Application No. 10/825,103  
Amendment dated May 14, 2007  
Reply to Office Action of March 5, 2007

Docket No.: SON-3000

**ANNOTATED SHEET SHOWING CHANGES**

FIG.9

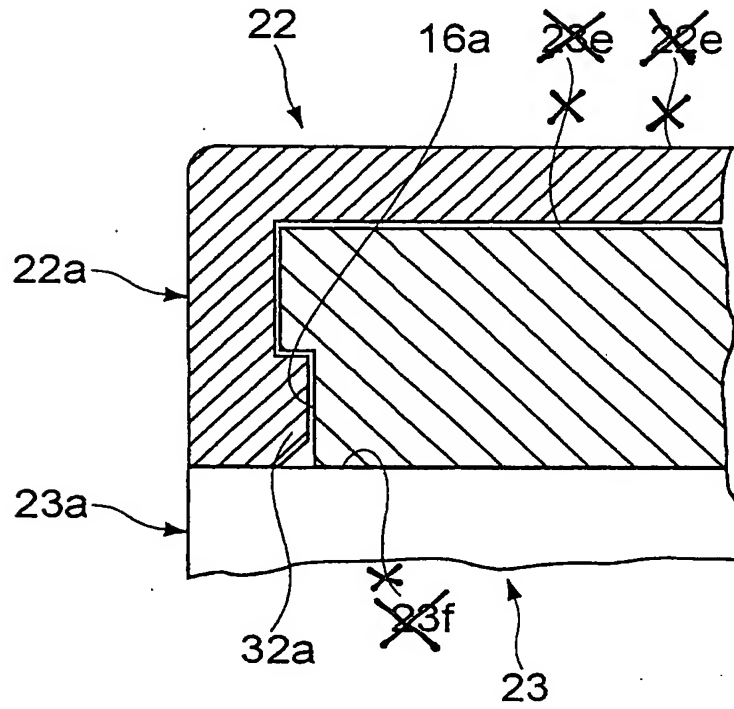
The attached sheet(s) of drawings includes changes to Figs. 3 and 9.
